Lower Thames Crossing

9.89 Responses to the Examining Authority's ExQ1 Appendix B – 4. Traffic & Transportation

DATE: September 2023
DEADLINE: 4

Planning Inspectorate Scheme Ref: TR010032
Examination Document Ref: TR010032/EXAM/9.89

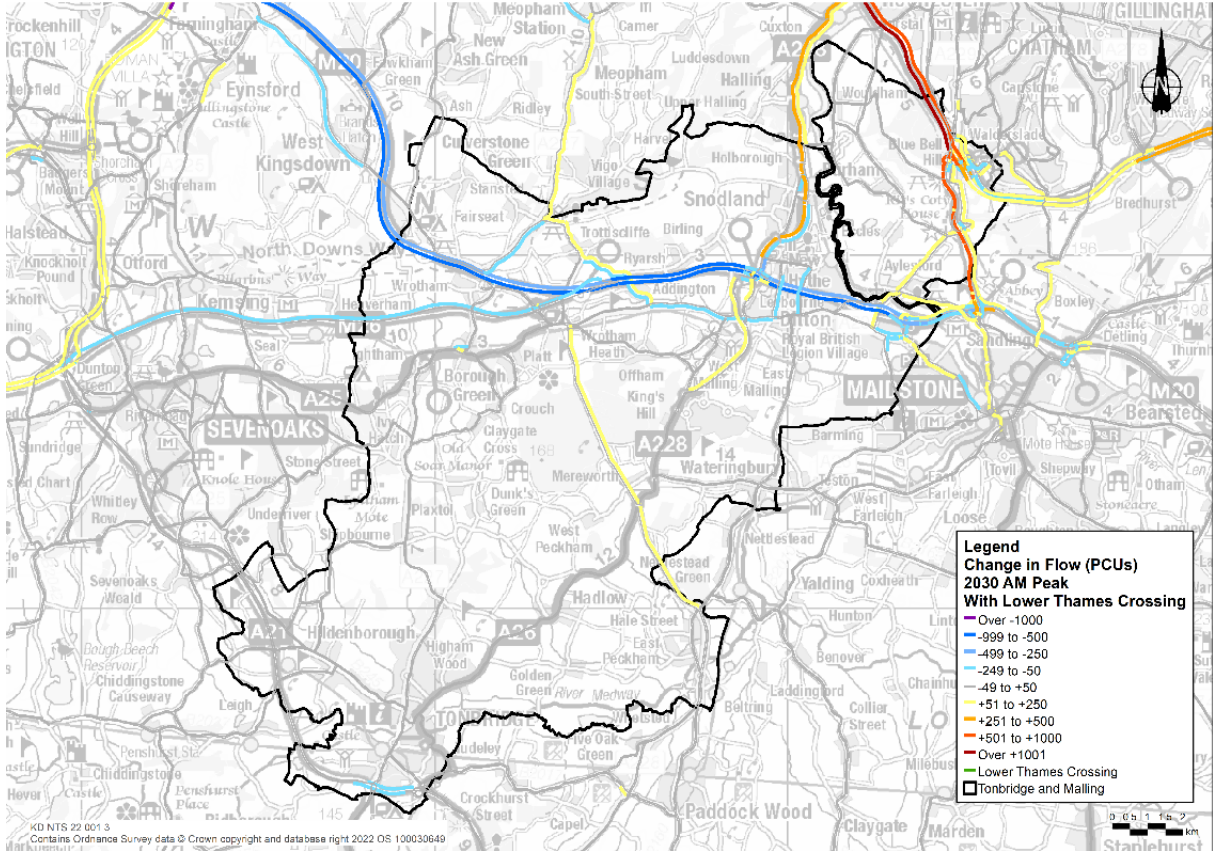
ExQ1_Q4.3.8	Tonbridge & Malling Council	<p>Benefits to Tonbridge & Malling’s Network</p> <p>Paragraph 3.4 of the Council’s LIR acknowledges that positive, neutral, and negative should be identified. Save for flows west of junction 4 M20, no other traffic benefits are identified in the LIR. Can Tonbridge and Malling Council confirm that there are no other locations in the borough that would experience positive effects?</p> <p>Response:</p> <p>The Applicant has extracted forecast flow changes as a result of the Project within the Tonbridge and Malling local authority area, as shown in Plates 1 and 2 for the AM and PM peaks in 2030. The Tonbridge and Malling local authority area extents are shown on the maps.</p> <p>The plates show that in addition to flows west of M20 junction 4 as identified by the authority, flows on the M20 between junctions 4 and 5 are also forecast to see a reduction in both directions in both peak periods. Flows on</p>

PINS ID	External Stakeholder (where applicable)	Question / Response
		<p>the M26 are also forecast to see a reduction of up to 249 Passenger Car Units (PCUs) (eastbound only in the AM peak and both directions in the PM peak) for its entire length. Some local roads within Leybourne are also forecast to see a reduction of up to 249 PCUs including the A20 and A228.</p> <p>Plate 2 Forecast flow changes as a result of the Project, AM peak, 2030, Tonbridge and Malling</p>
